STAFF RECOMMENDATION 1112 Montrose Avenue September 18, 2019

Application: New Construction-Infill
District: Waverly-Belmont Neighborhood Conservation Zoning Overlay
Council District: 07
Base Zoning: R8
Map and Parcel Number: 118010123
Applicant: Kaitlyn Smous, Nine 12 Architects
Project Lead: Jenny Warren, jenny.warren@nashville.gov

Description of Project: The application is for the construction of a new infill duplex.

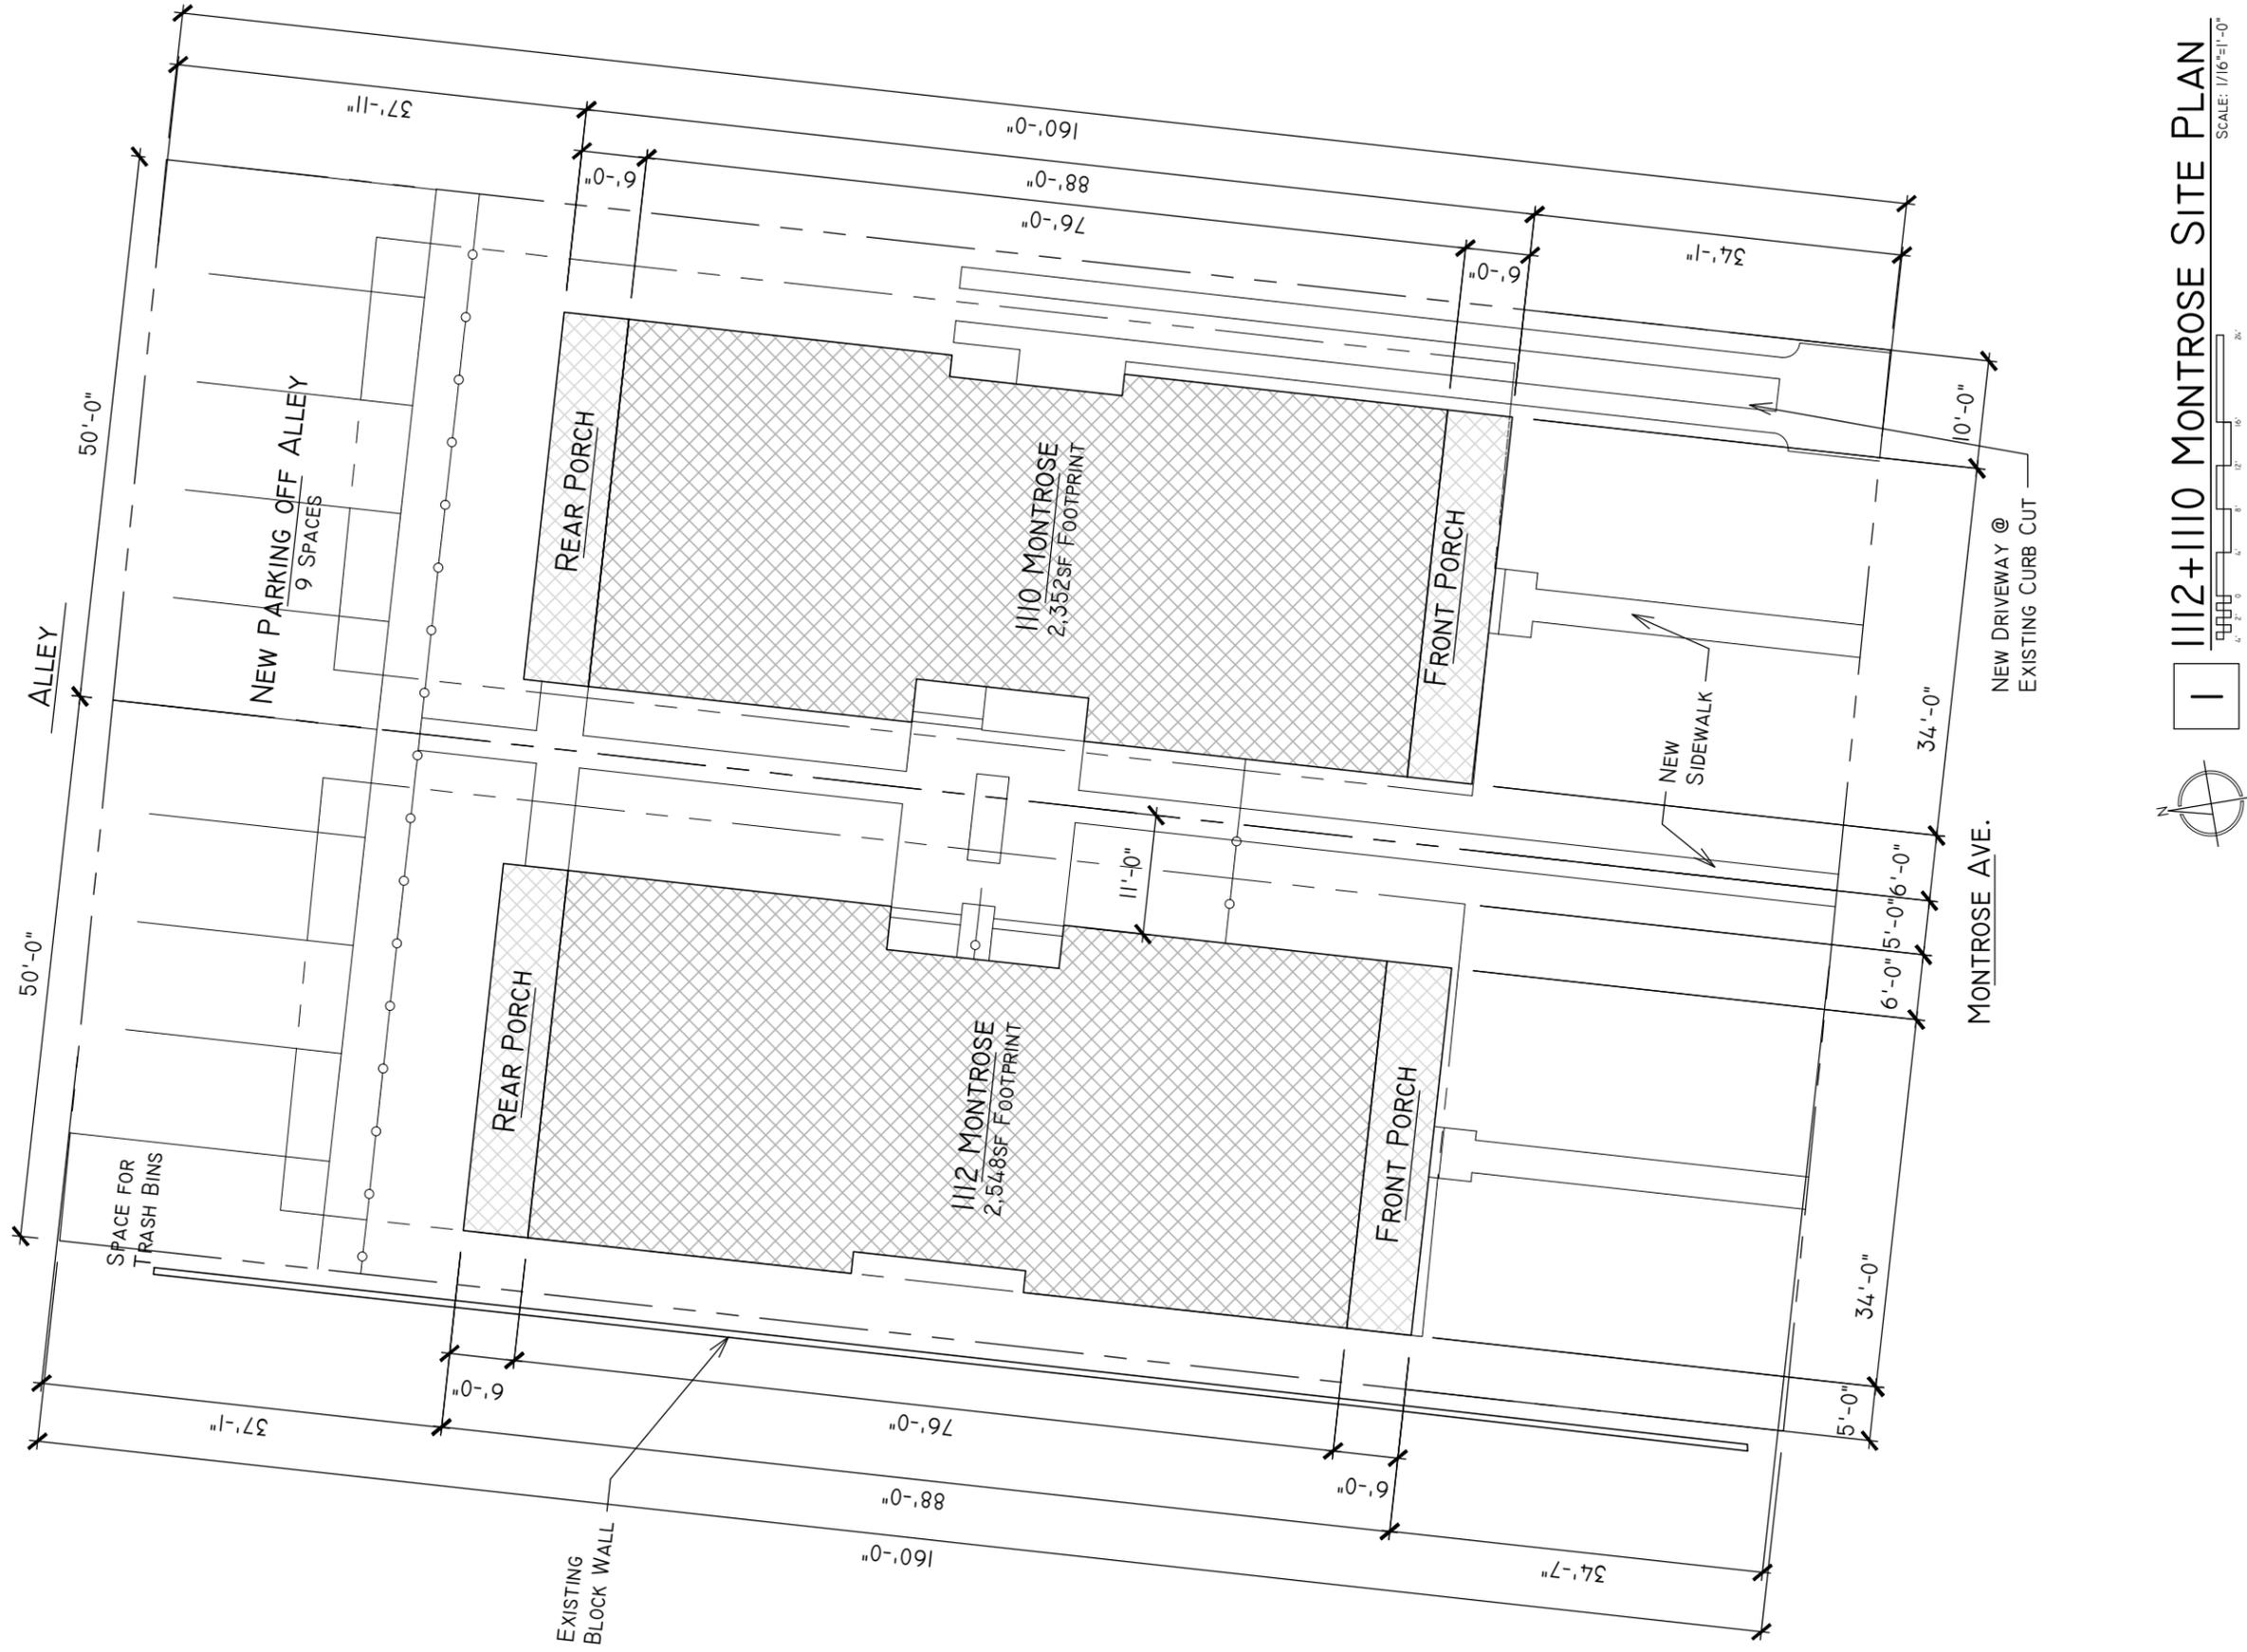
Proportion and Rhythm of Openings: The windows on the proposed building are all generally twice as tall as they are wide, thereby meeting the historic proportions of openings. There are no large expanses of wall space without a window or door opening. Staff finds the project's proportion and rhythm of openings to meet Section III.G. for new construction-proportion and rhythm of openings.

SITE PLAN

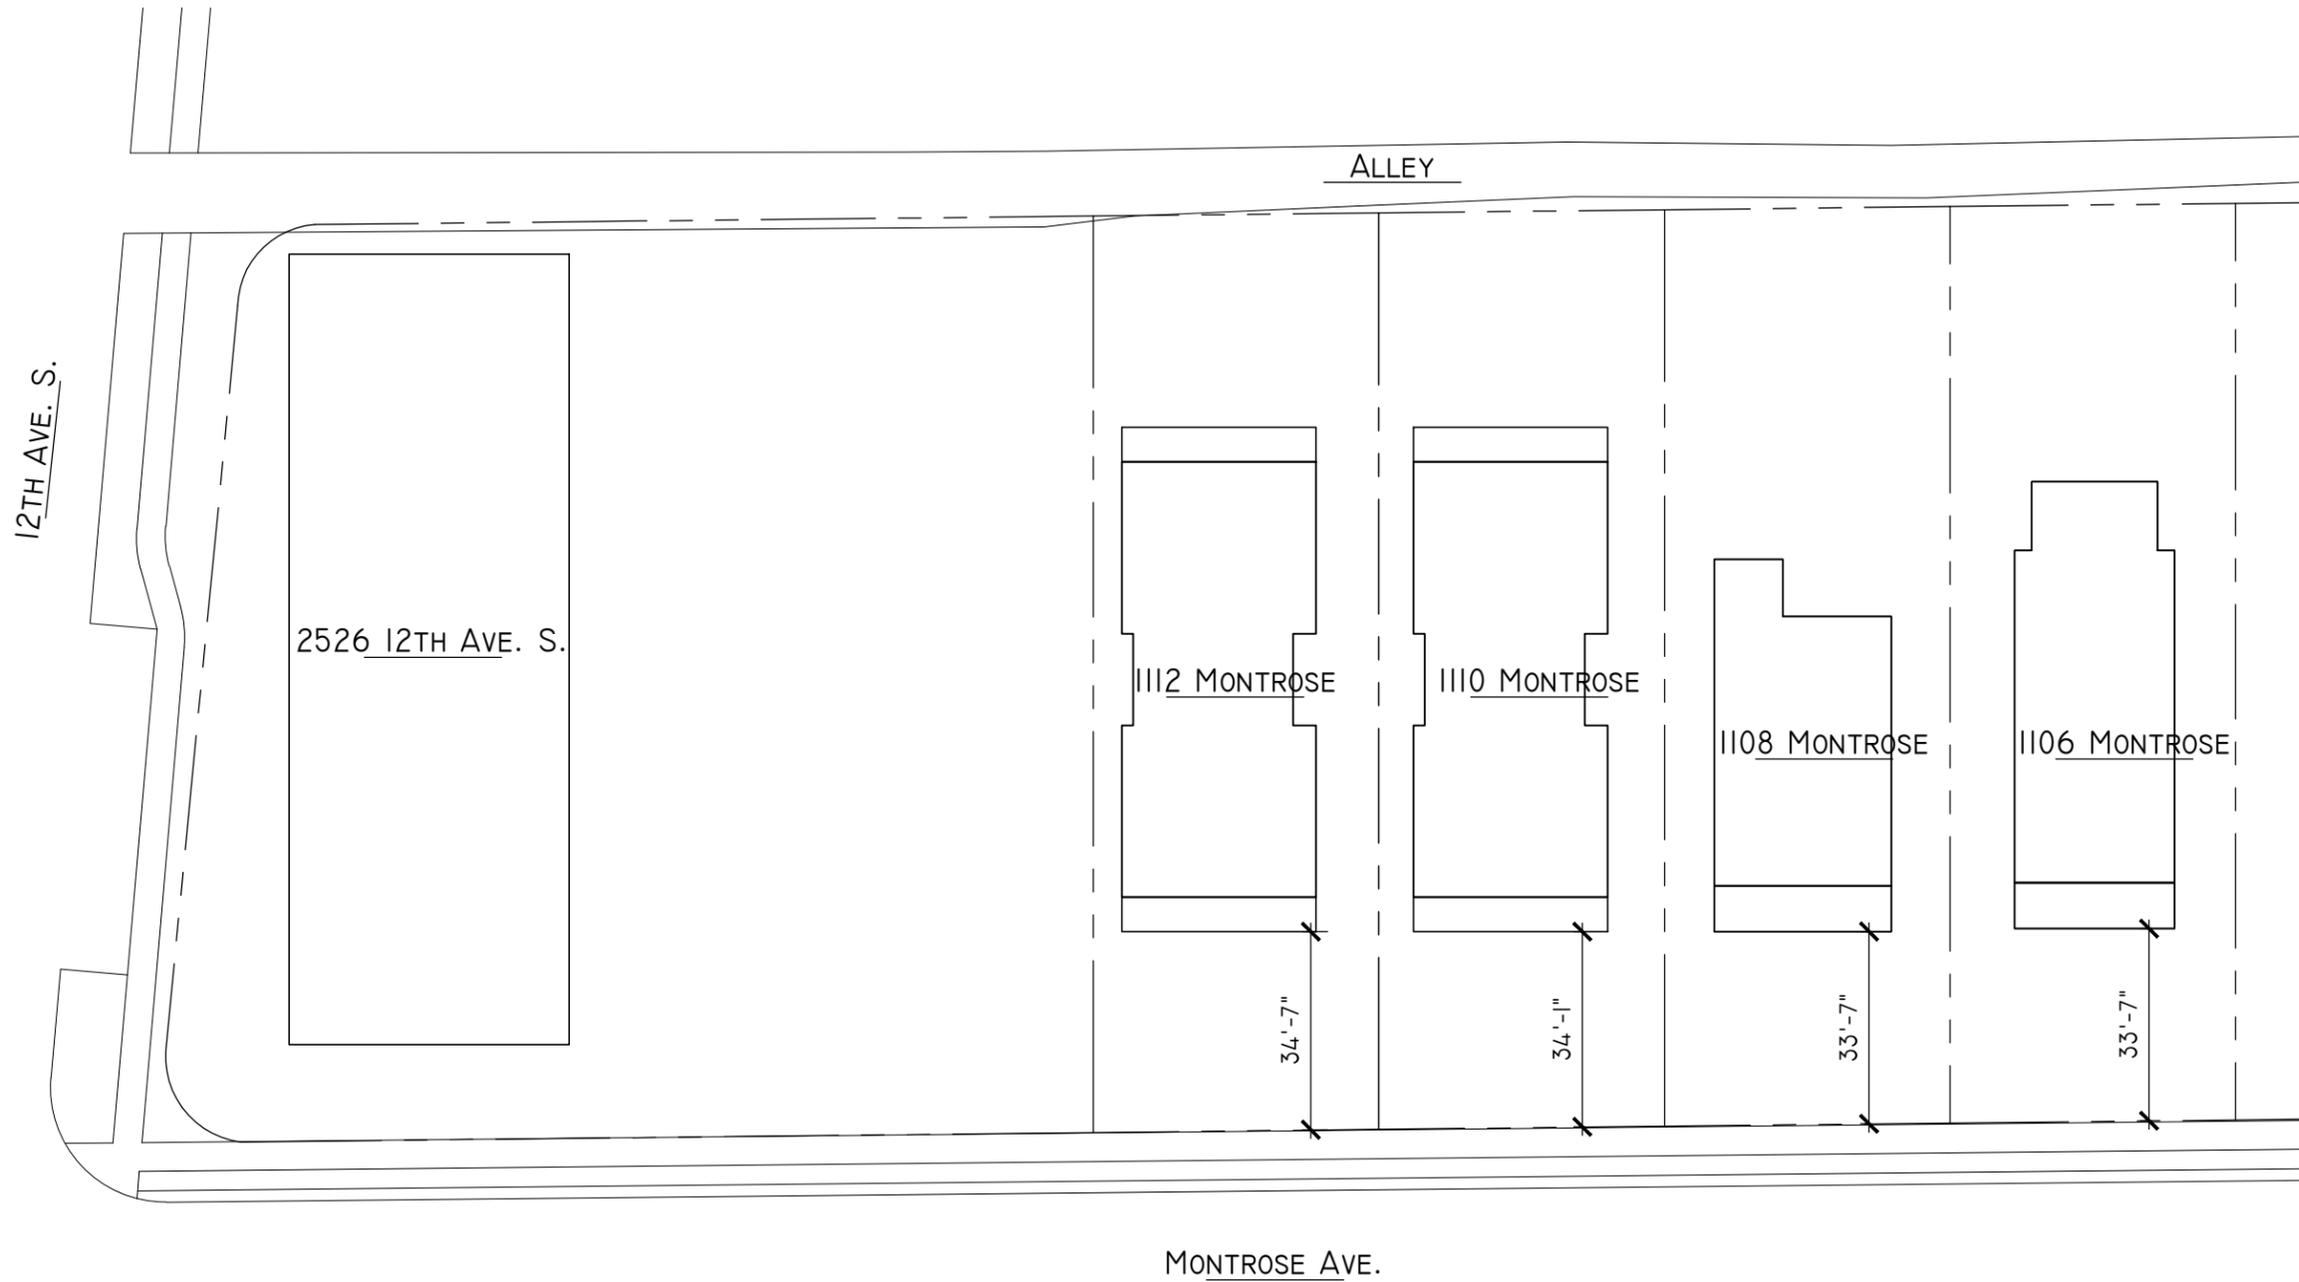
The approved setbacks are not changing.

With Staff review and approval of the front setback in the field, the project meets section III.C for setback and rhythm of spacing for new construction.

1112 MONTROSE 1ST FLOOR PLAN

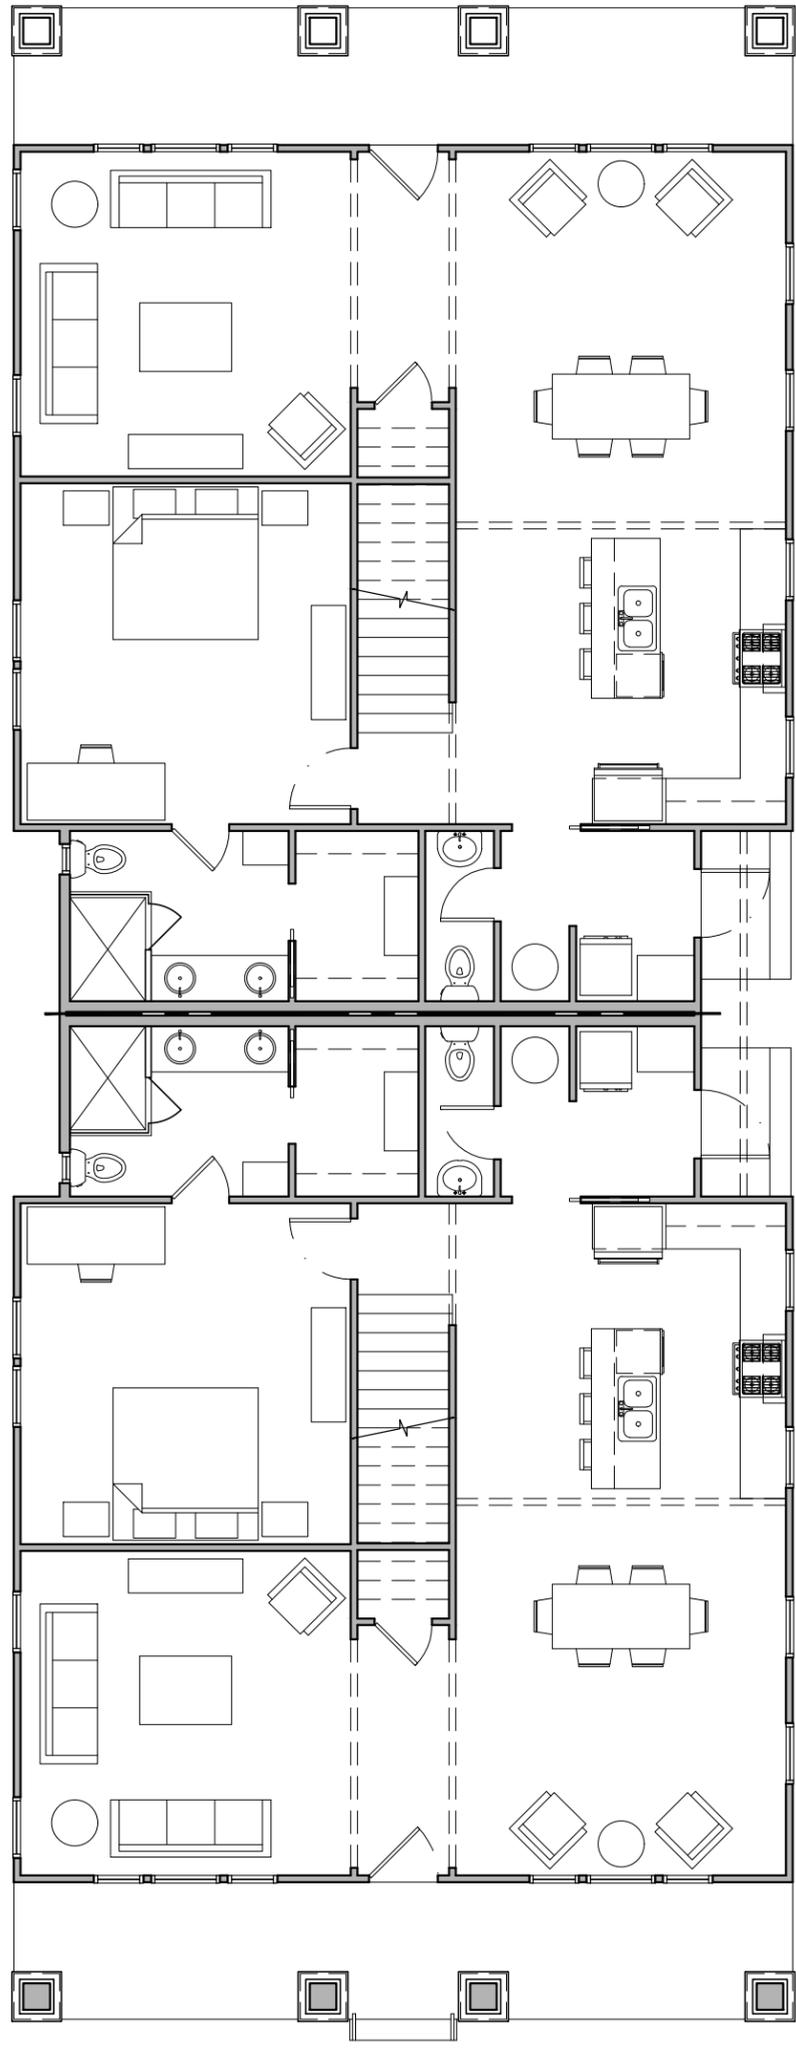
Orientation: The proposed infill faces Montrose Avenue with a full-width front porch that is six feet (6') deep. There is a walkway from the front porch to the existing sidewalk on Montrose. This is compatible with the historic context. The second unit is accessed via an additional walkway to the right of 1112 Montrose that runs from a side door to the Montrose Avenue sidewalk. The second unit has a porch which faces the alley and additional parking.
